QUARANTINE NOTICE

Reference number:	QN-07-1201	Issued: 21 December, 2018
Subject:	Differential Breather Pipe Extension	
Model(s):	DBS Superleggera	
VIN Range:	Refer to the separately published list of affected Vehicle Identification Numbers (VINs)	
Applicable to:	All Dealers	
Distribute to:	After Sales Manager Executive Manager Service Manager Sales Manager	Warranty Staff Technician(s) Parts Staff

Figure 1

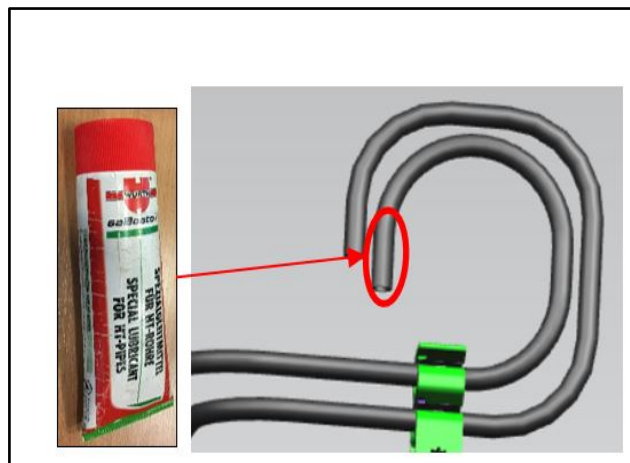
1. Remove the rear right side wheel-arch liner (refer to Workshop Manual procedure 01.08.AK).
2. Apply a small quantity of lubricant suitable for high temperature applications to the differential breather pipe (refer to Figure 1).

Figure 3

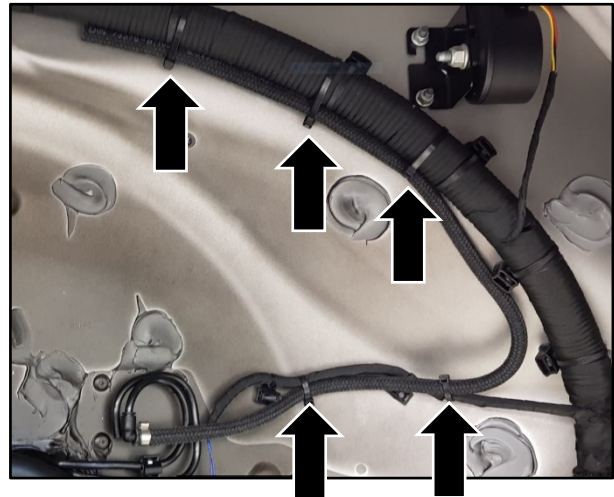
4. Use five cable ties to attach the extension pipe in the applicable positions (refer to Figure 3).
